Access Compliance Report Public Rights-of-Way (Curb Ramps)

Intersection ID: 15439Main Street: TROTTERS_RIDGE_RDCross Street: JEWELFLOWER_RDLocation:NEADA ID: B240B866DFC6Ramp Type: PerpInitial Pass/Fail: FailOverall Compliance: NoSeverity Score: 21.25

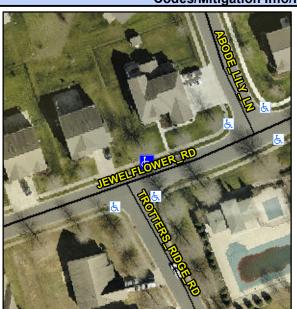
Not Found, R304.5.1, R304.2.2

Field Measurements/Component Compliance							
Comp	oliance Description	Data	Comp	oliance Description	Data		
N/A	Ramp Length (in)	48.5	No	Ramp Slope (%)	9.6		
No	Ramp Width (in)	46.5	Yes	Ramp XSlope (%)	1.9		
N/A	Flare Type LT	N/A	N/A	Flare Type RT	N/A		
N/A	Flare Slope LT (%)	N/A	N/A	Flare Slope RT (%)	N/A		
N/A	Flare Traversable LT?	N/A	N/A	Flare Traversable RT?	N/A		
N/A	Landing Length (in)	N/A	N/A	DWS Provided?	N/A		
N/A	Landing Width (in)	N/A	N/A	DWS Contrast?	N/A		
N/A	Landing Slope (%)	N/A	N/A	DWS Length (in)	N/A		
N/A	Landing X Slope (%)	N/A	N/A	DWS Full Width?	N/A		
N/A	Landing Curb? (Y/N)	N/A	N/A	DWS Offset (in)	N/A		
N/A	Shared Landing?	N/A					
N/A	Gutter Ponding?	N/A	N/A	Gutter Slope (%)	N/A		
N/A	Gutter Lip Ht (in)	N/A	N/A	Gutter X Slope (%)	N/A		
N/A	Painted X Walk1?	No	N/A	Painted X Walk2?	N/A		
	X Walk 1 Direction	To S		X Walk 2 Direction	N/A		
N/A	X Walk 1 Width (in)	N/A	N/A	X Walk 2 Width (in)	N/A

Remove & Replace Entire Ramp.
